FILE NO.: HR 17-04: Historic Review for a new Public Works Operations facility in the McLoughlin Conservation District.

REQUEST: Proposal for construction of a new operations facility for the Oregon City Public Works Department in the McLoughlin Conservation District.

HRB DECISION: Approved With Conditions

Upper Lot Planting Plan

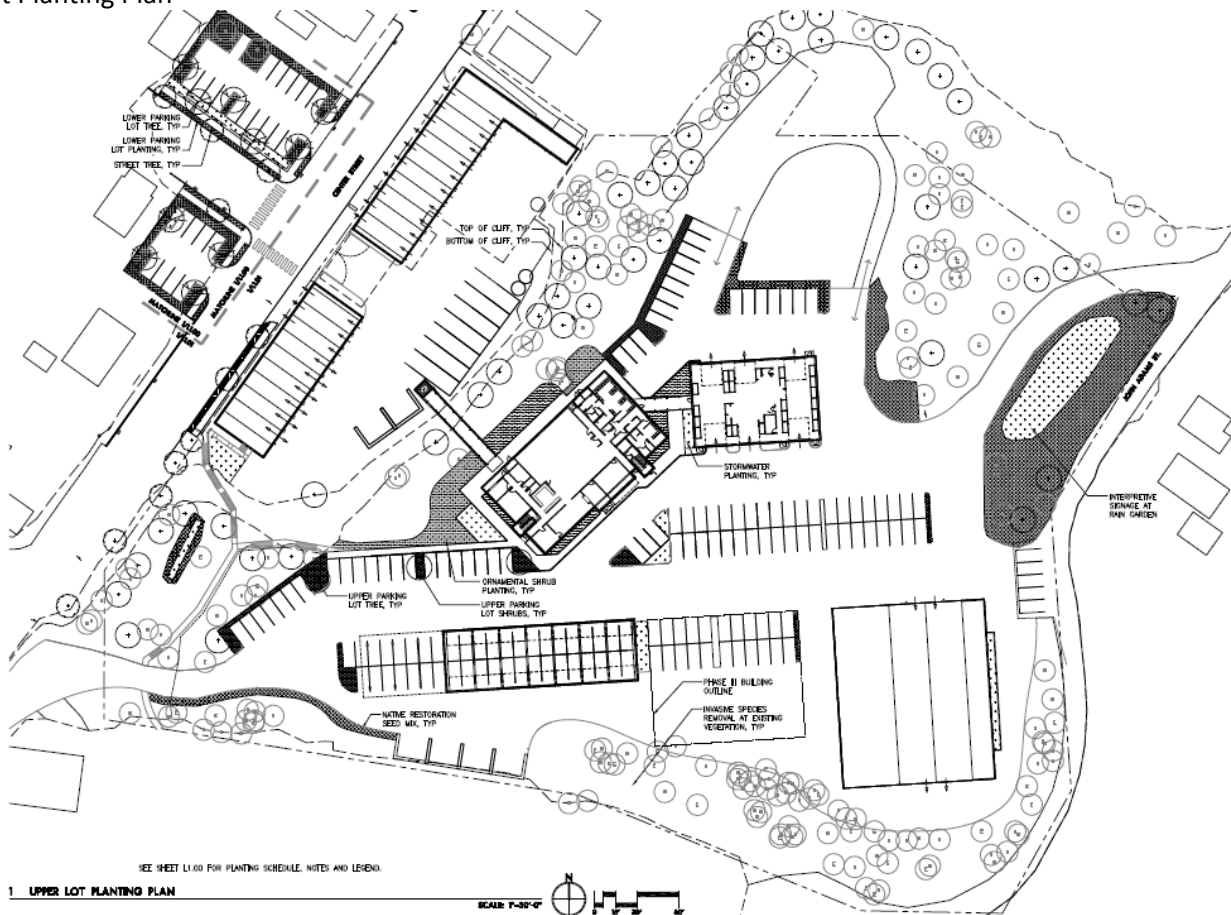
- b. At least four (4) native trees, at least 15 feet in height when mature, and eight (8) shrubs (at least 3 ½ feet in height when mature, shall be planted along the northwest façade of the two story office building facing the South Center Street Right-of-Way.(P)

Finding: Complies with Condition. The applicant appears to have 20% of the lot landscaped as identified on sheet L100 and L101, but the calculation was not provided. Prior to issuance of a permit associated with the proposed development, the applicant shall submit documentation demonstrating that a minimum of 20% of the site is landscaped. **HRB has determined that it is possible, likely and reasonable that the applicant can meet this standard through the Conditions of Approval.**

2. The applicant shall submit a landscaping plan with the following changes:
 - a. Documentation indicating that a minimum of 20% of the site is landscaped.(P)

Elevator

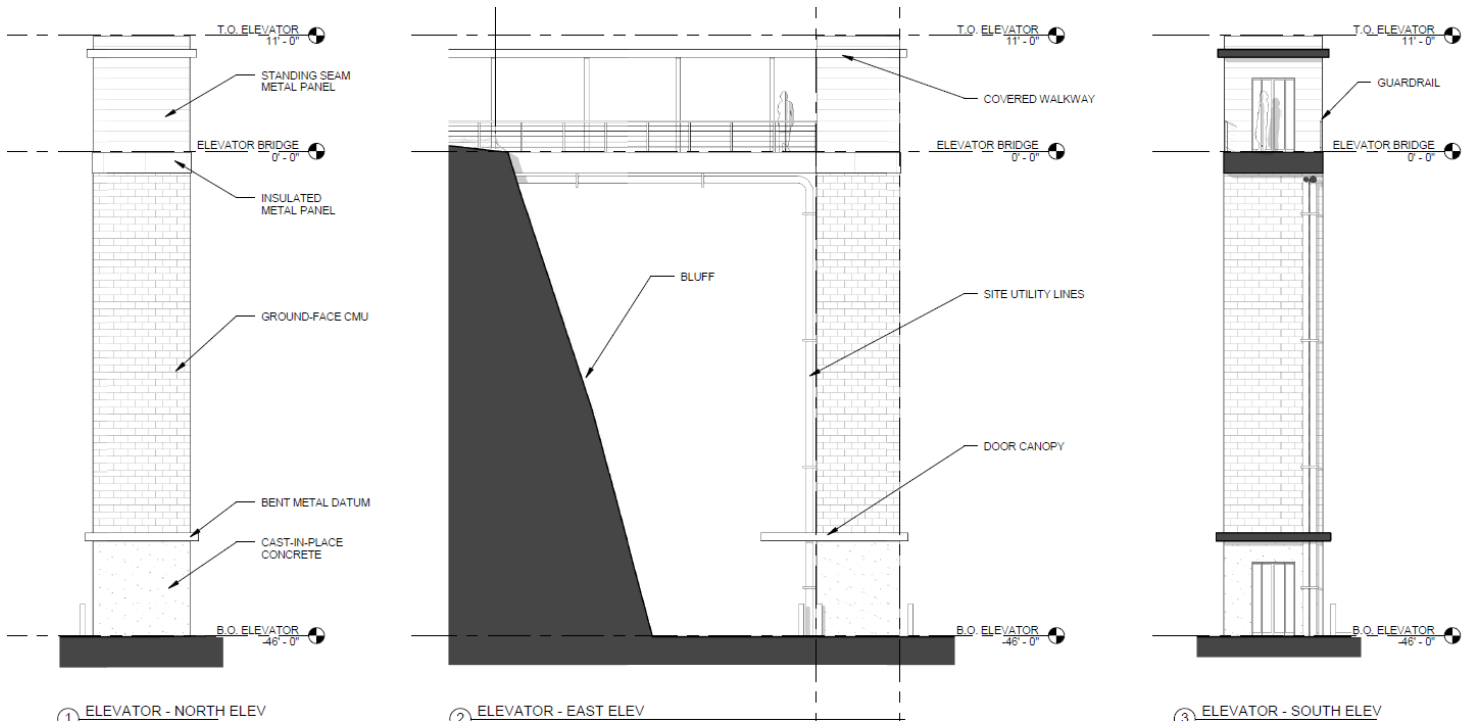
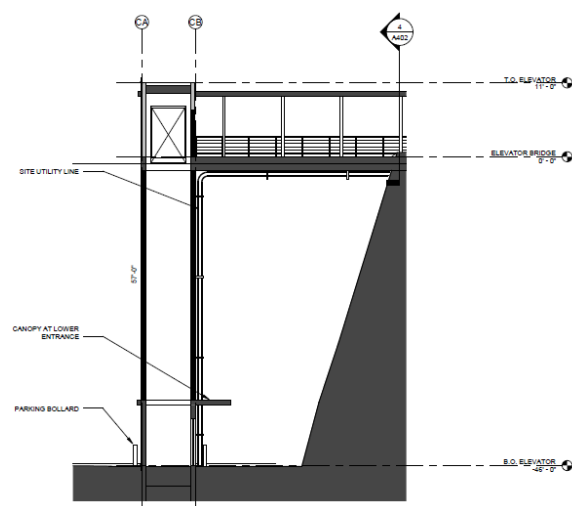
6. The materials on the elevator shall be comprised of the same materials proposed to be used on the building. Those materials include stone and metal exterior façade pieces designed in neutral and soft earth tones colors.
